City of Albuquerque

RE: DRAINAGE PLAN FOR GRECIAN PARK
(E-14/D1A)

PONDING REQUIREMENTS

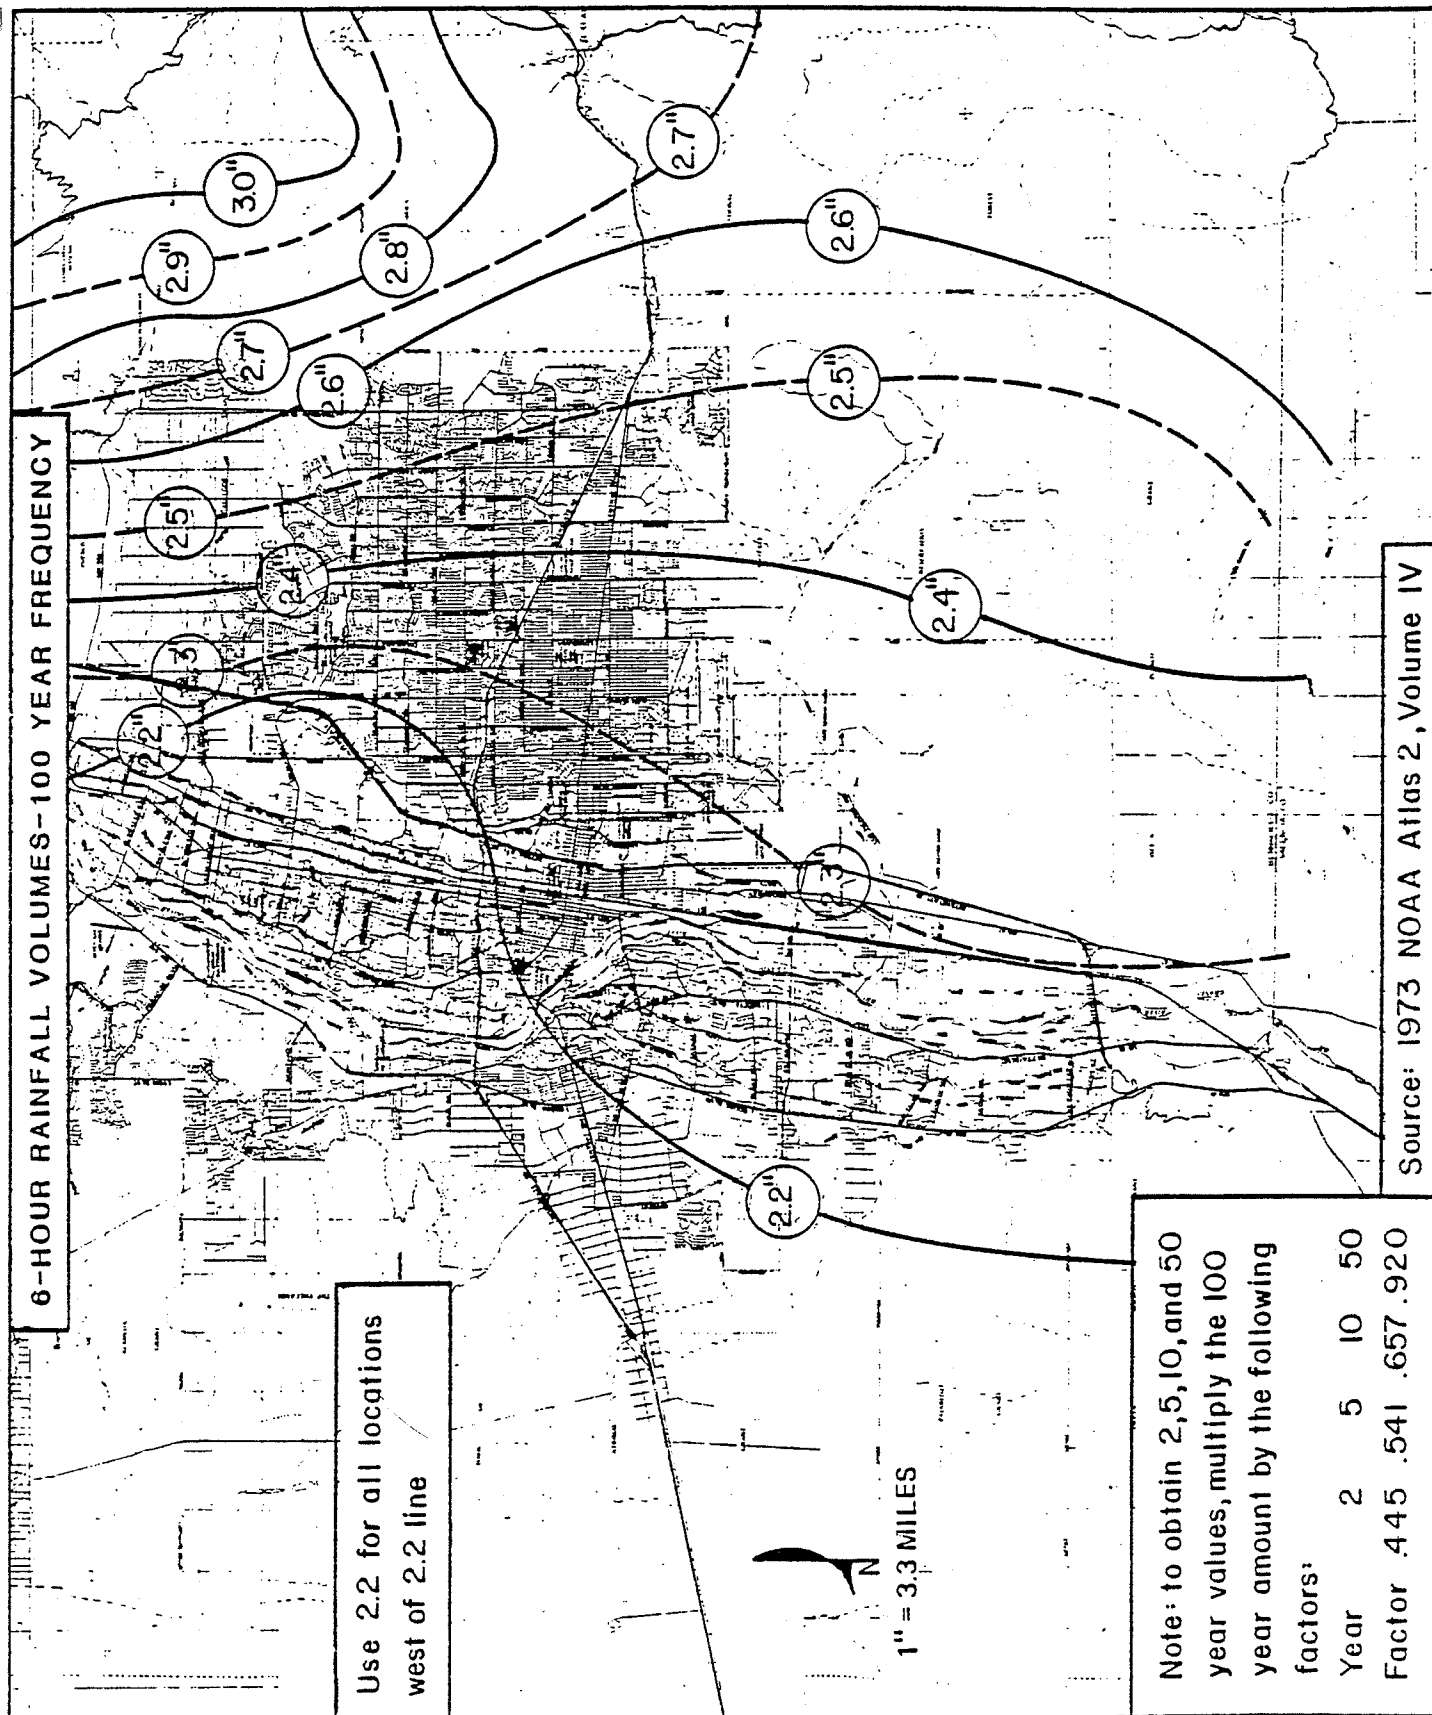
AREA DIVIDED INTO FOUR BASINS
AS SHOWN ON DRAWING.

USE 2.2 in. OF RAINFALL PER DPM 22.2 D-1

USE CN=61 PER DPM 22.2 C-2

Therefore Direct Runoff = 0.2 inches per 22.2 C-4

$$\frac{0.2 \text{ in}}{12} \times 1.29 \text{ Ac} \times 43560 \frac{\text{sq ft}}{\text{Ac}} = 940 \text{ cu ft}$$

$$\frac{0.2 \text{ in}}{12} \times 1.84 \text{ Ac} \times 43560 = 1340 \text{ cu ft}$$

$$\frac{0.2 \text{ in}}{12} \times 0.4 \text{ Ac} \times 43560 = 290 \text{ cu ft}$$

$$\frac{0.2 \text{ in}}{12} \times 0.37 \text{ Ac} \times 43560 = 270 \text{ cu ft}$$

GRECIAN PARK

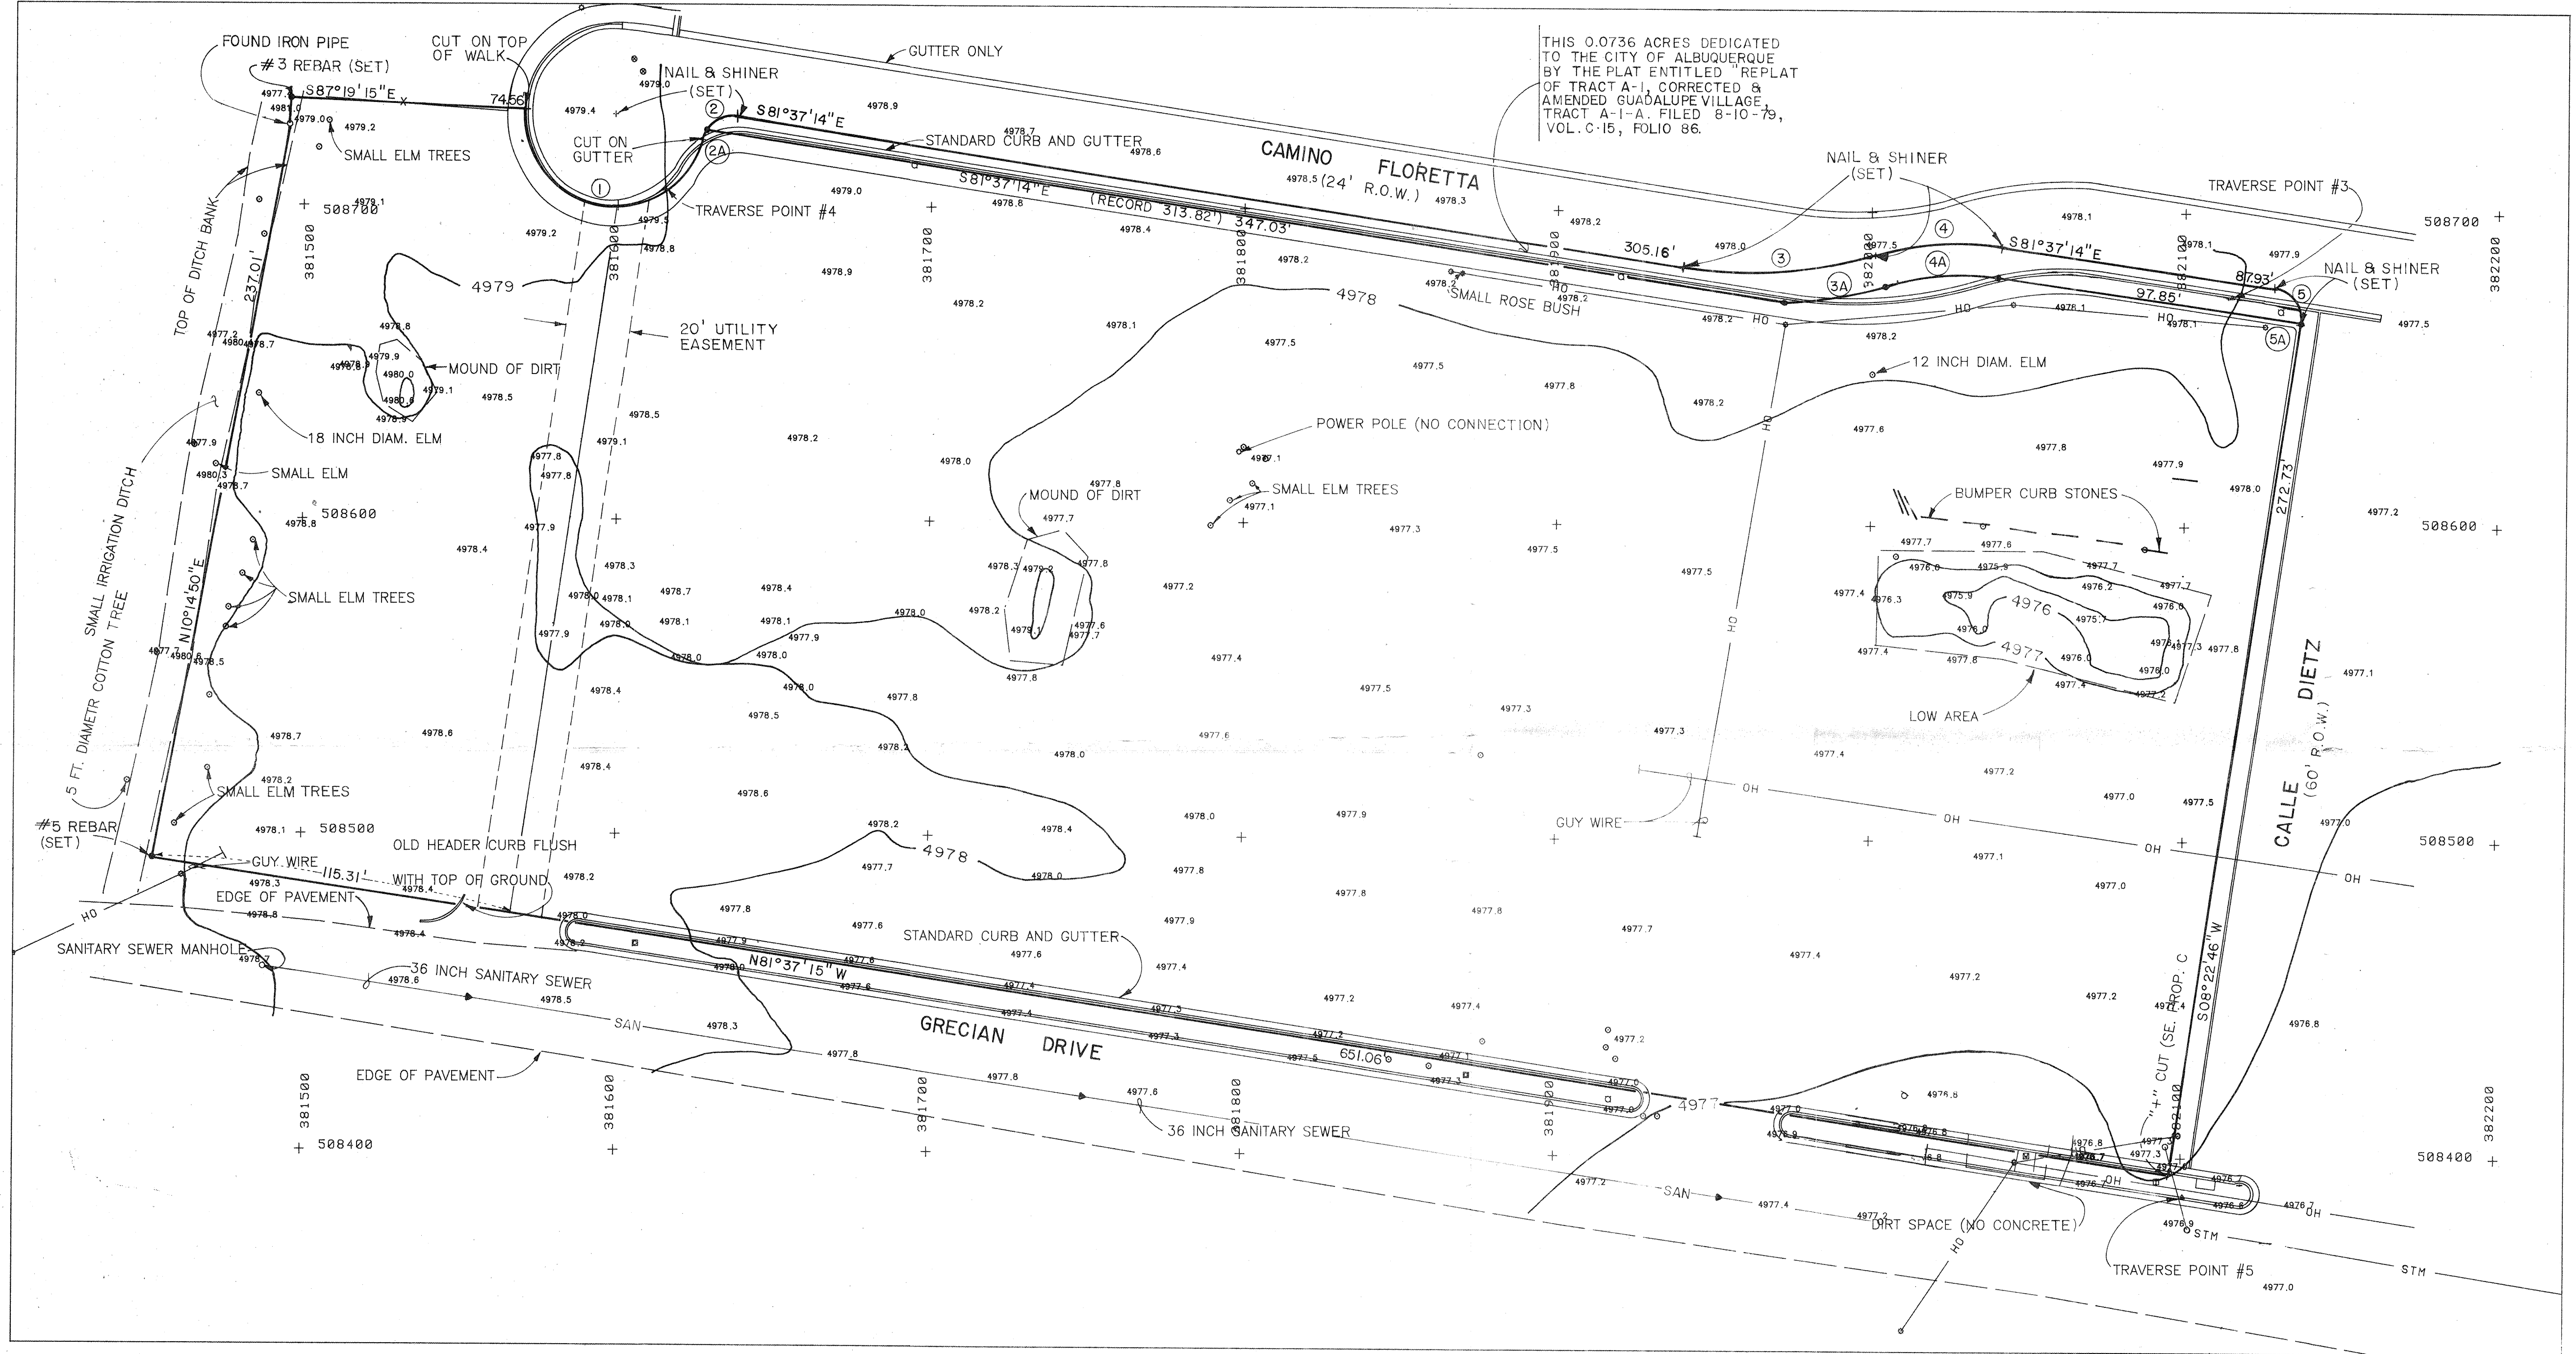
Retention ponds will be an acceptable method for controlling runoff from the park. Minimal downstream drainage facilities and the pervious nature of a park allow the use of retention ponds.

I have divided the park into four drainage basins as shown on the attached drawing. Basin 1 is bounded on the west by an existing ditch. Minor off-site flows should be allowed to enter the park from Grecian Drive and the private property west of Camino Floretta. The proposed retention volume is in excess of what is required. Basin 2 is bounded by Camino Floretta and Grecian Drive. My only recommendation is that the nuisance flows be directed to the center pond and not be allowed to run in the adjoining streets. The proposed retention volume is in excess of what is required. Basin 3 is directing its runoff to Calle Diez. This drainage solution will have nuisance flows on relatively flat streets where ponding is an existing problem. I suggest using swales and a small depression to capture the basins runoff. This pond would be minimal as shown on my calculation sheet. Basin 4 has the same problem as Basin 3 and I make the same suggestion. If depressions are not acceptable, please elevate the property borders to keep nuisance flows in the park.
